ENVIRONMENTAL HEALTH SERVICES
ENVIRONMENTAL PROTECTION
1131 Harbor Bay Parkway, Suite 250
Alameda, CA 94502-6577
(510) 567-6700
FAX (510) 337-9335

November 5, 2012

Subject: **Comment Letter - BP 11133 Case Closure Summary**, Revised Notice of Opportunity for Public Comment; Underground Storage Tank Cleanup Fund Case Closure Recommendation; Claim Number 5502; Fuel Leak Case No. RO0000403; Global ID # T0600100210; BP #11133, 2220 98th Avenue, Oakland, CA 94603

2220 98th Ave, Oakland, CA - Parcels Notified By SWRCB

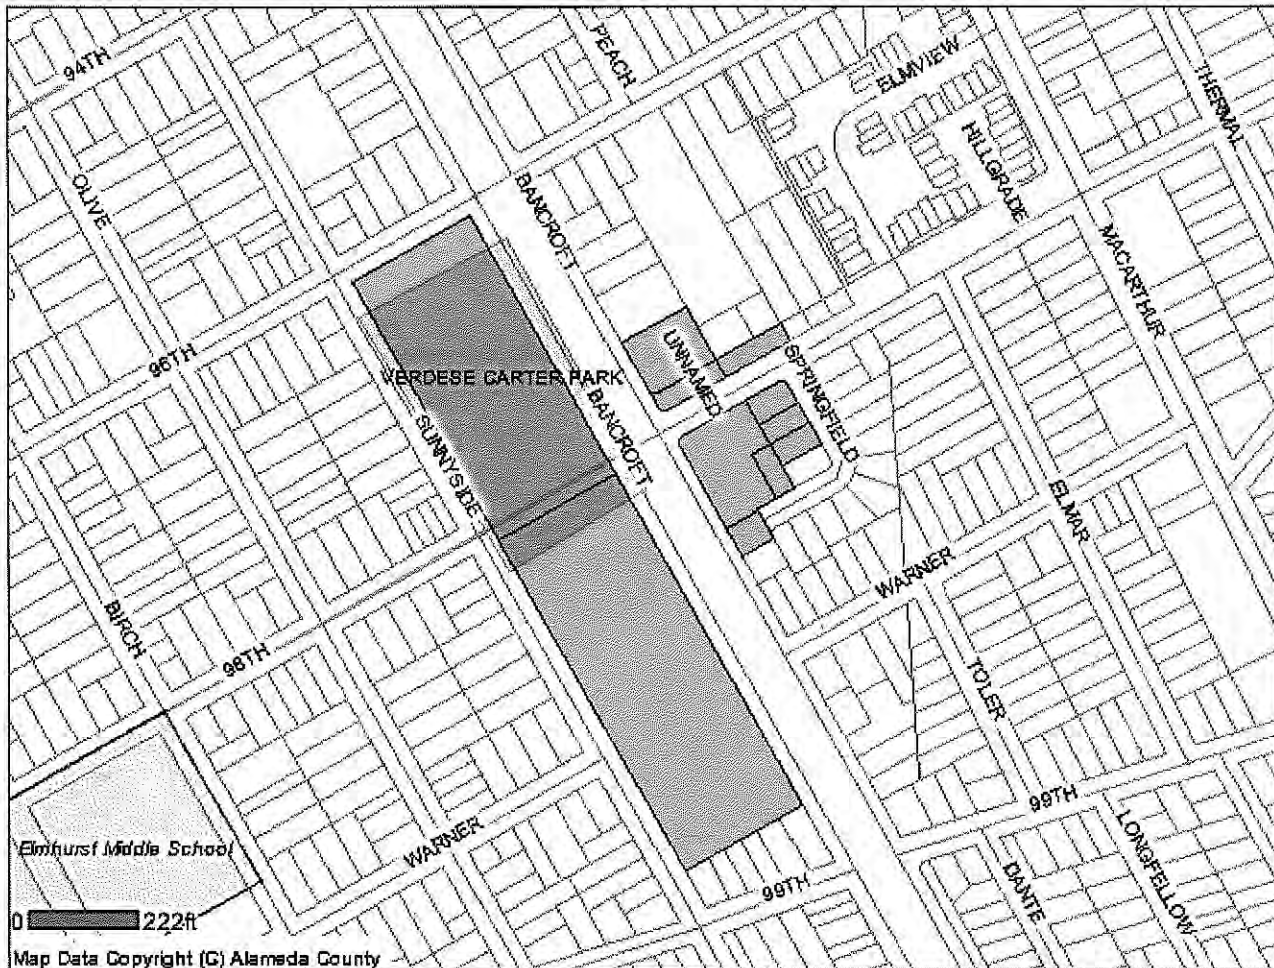
While the USTCF has made the *UST Case Closure Summary* available for public comment on the SWRCB's website, it appears to have failed to notify in a timely basis all interested parties, *including all owners and occupant of property potentially impacted by the petroleum release*, as required by the LTCP, CCR Chapter 16, and Chapter 6.7 of the H&SC. According to the LTCP Notification Requirements "municipal and county water districts, water replenishment districts, special act districts with groundwater management authority, agencies with authority to issue building permits for land affected by the petroleum release, owners and occupants of the property impacted by the petroleum release, and owners and occupants of all parcels adjacent to the impacted property shall be notified of the proposed case closure and provided a 60 day period to comment. The regulatory agency shall consider any comments when determining if the case should be closed or if site specific conditions warrant otherwise."

The USTCF's *Revised Notice of Opportunity for Public Comment*, dated September 10, 2012, states that "a copy of the *Case Closure Summary* has been provided to the owner/operator, environmental consultant of record, the local agency that has been overseeing corrective action, the local water purveyor, and the water district specified by H&SC section 25299.39.2 subdivision (a)(1)." Concerned by this limited list of parties, ACEH contacted the USTCF and requested the list of recipients that the *Revised Notice of Opportunity for Public Comment* was sent to. Our review of the list of recipients (received by ACEH on October 22, 2012) indicates a lack of notification of many of the owners and residents of surrounding properties potentially affected by off-site migration of free product, contaminated groundwater, and/or soil gas, including residents of parcels owned by the Oakland Housing Authority. The

USTCF's list of recipients and an appropriate public notification area map and a list of owners and tenants identified by ACEH's search of the County of Alameda Assessor's Office Property Value System who should receive notification of the USTCF's recommendation for case closure is provided as attachments to this response letter.
